Council Meeting Agenda

February 5, 2024

7:07 p.m. Public Hearing/Motion: To consider a permit application amendment, submitted by Daniel Bremer-Wirtig and Rebecca Lamadrid, to replace the driveway at the property located at 5613 Warwick Pl. The applicant is seeking a variance from the Town Code which requires all

LaMadrid - Bremer
Residence

L-1
SHEET 1 OF 2

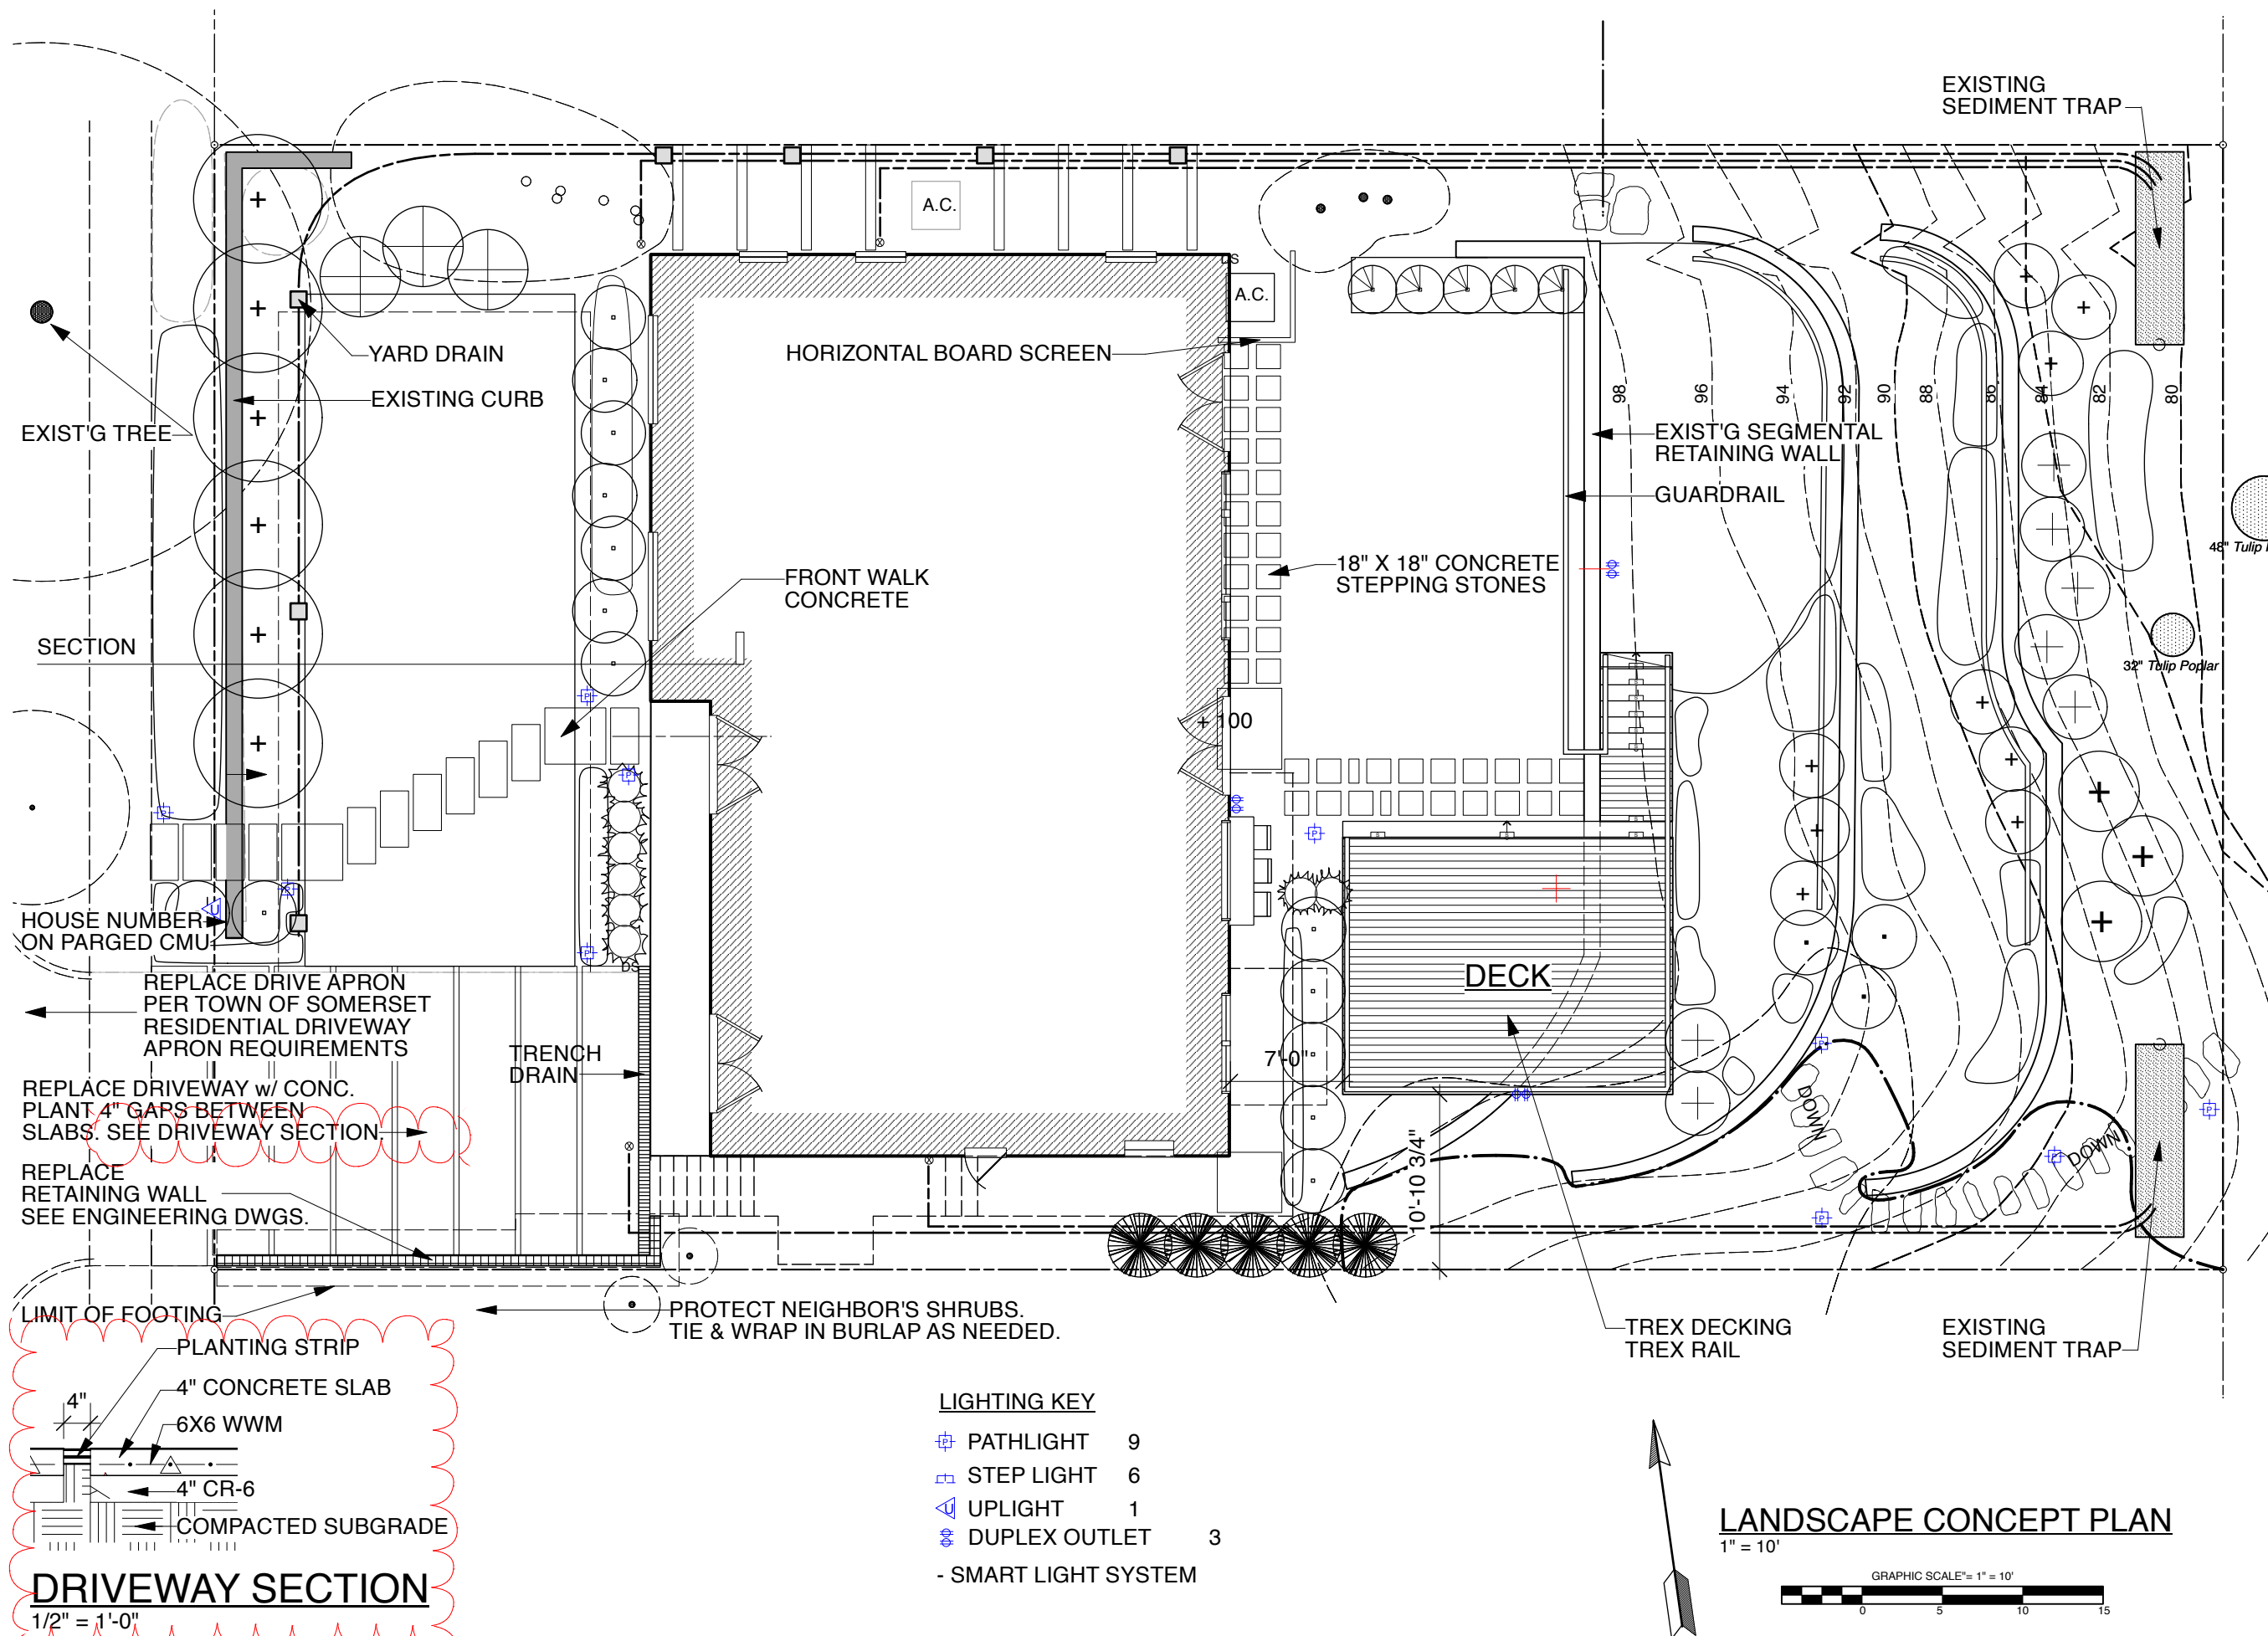
1. Are you still planning to include the rain barrels that were on previous plans?
No. The rain barrels were removed since revision 10.23.23. The current revision is dated: 12.19.23.
2. Will the proposed retaining wall encroach onto the neighbor's property?
Yes. Contractor believes the footing of the current retaining wall that is failing and requires replacement encroaches underground onto the neighbor's property. This has been disclosed and discussed with the neighbors, Mr. and Mrs. Lasky. These disclosures were submitted as part of the application and are documented by:
 - a. A memo dated 10/19/23 from Ed Bisese from Denchfield Landscaping to the applicant; and,*
 - b. Drawings, specifically the Site Retaining Walls by Rathgebre/Goss Associates and L-1 by Denchfield Landscaping, Inc.*

- c. The Plans received on Oct. 24, 2023, show the proposed retaining wall construction will encroach on the neighbor's property. Do you have a letter or email granting their permission to work on their lot?

Drive Details

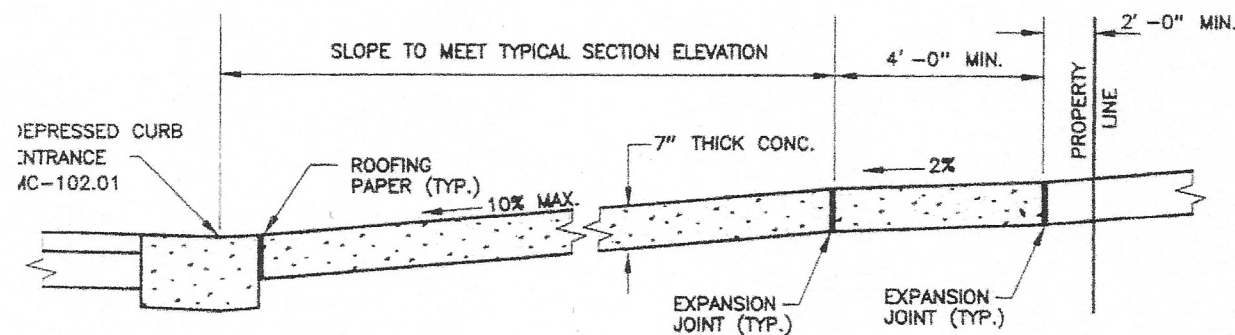
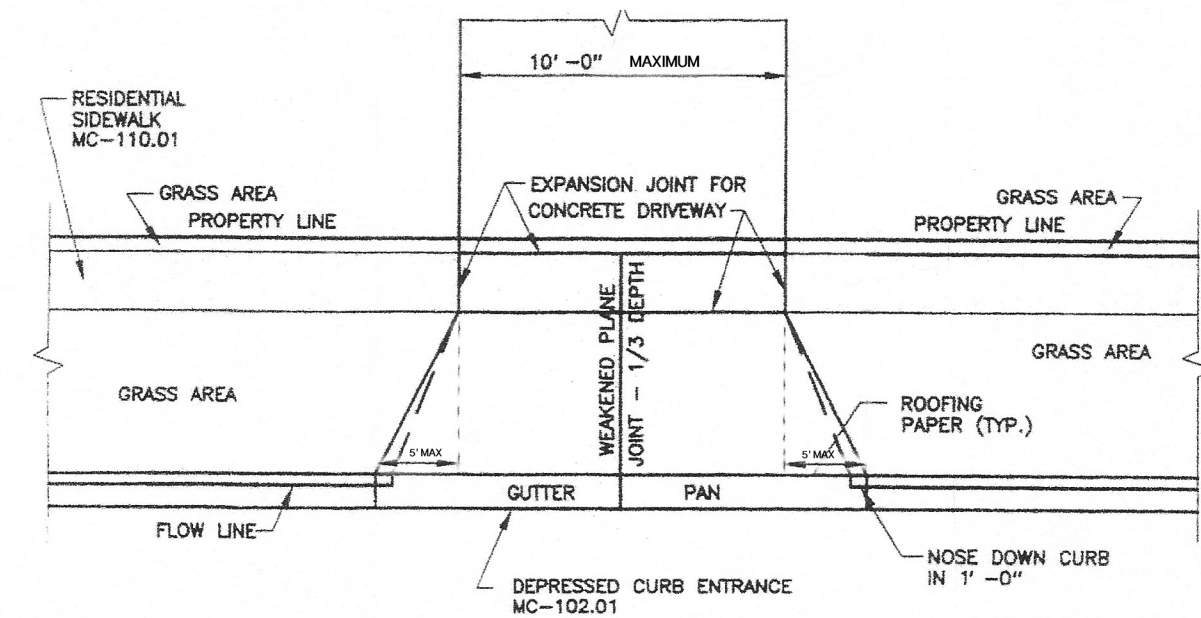
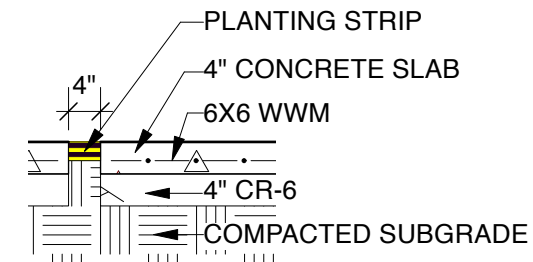
7. The proposed driveway note says "Replace Driveway w/ conc. plant 4" gaps between slabs". Is this intended to be a pervious driveway? Please clarify and show a section of driveway.
The proposed driveway replaces an existing impervious driveway. The existing driveway slopes about 1% towards the house. The proposed driveway is to match

existing slope. The proposed driveway is to be made of concrete and will be impervious – See sheet L-3 for details.
